CLAIM REJECTIONS - 35 U.S.C. §112

Claims 1-7 and 9-10 are rejected under 35 U.S.C. §102(e) as being anticipated by Floyd et al. (U.S. Patent No. 6,069,043). Specifically, the Office Action states that Floyd et al. show all of the elements of the present invention recited in claims 1-7 and 9-10.

Fig. 2

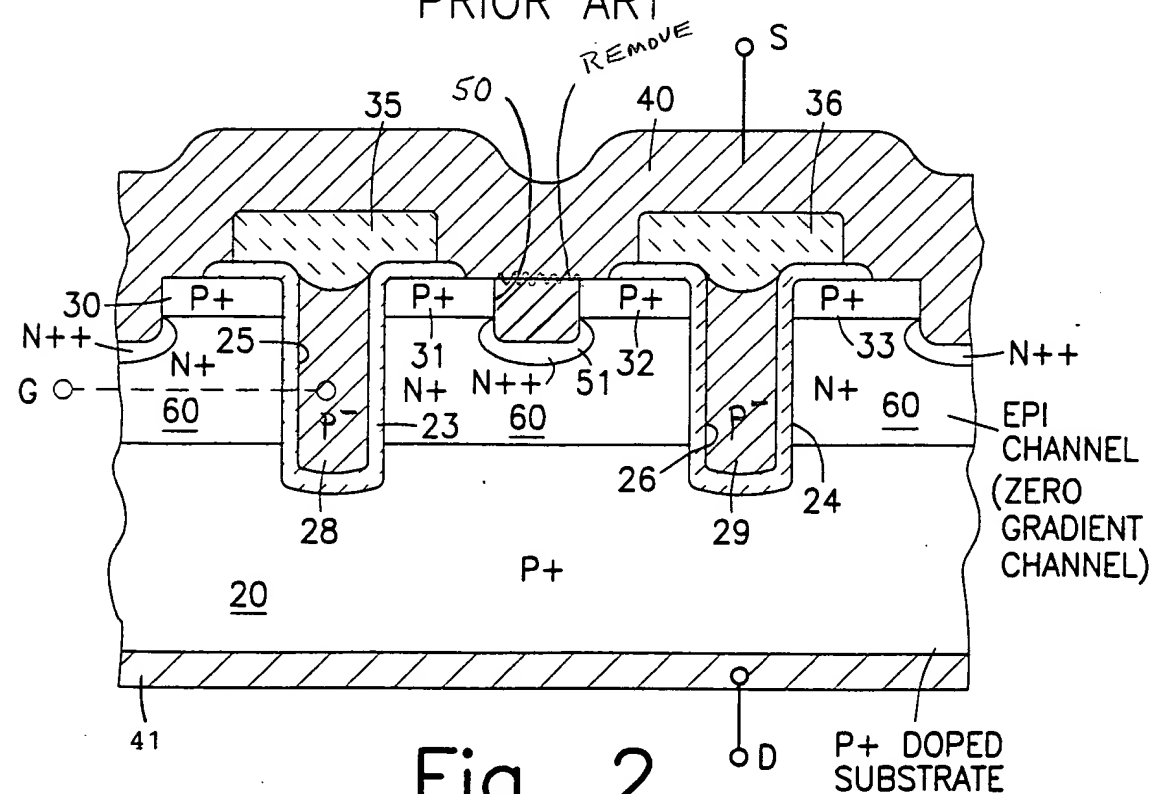
corrections to the specification and a new set of drawings in which Figs. 1-10 were redrawn for clarity. A review of the submitted drawings revealed discrepancies with the originally submitted drawings in Fig. 2.

Applicant now submits for review and approval a corrected drawing sheet showing corrections to Fig. 2. It is respectfully averred that no new matter is presented, but rather corrections to conform the redrawn Fig. 2 with that which was originally filed.
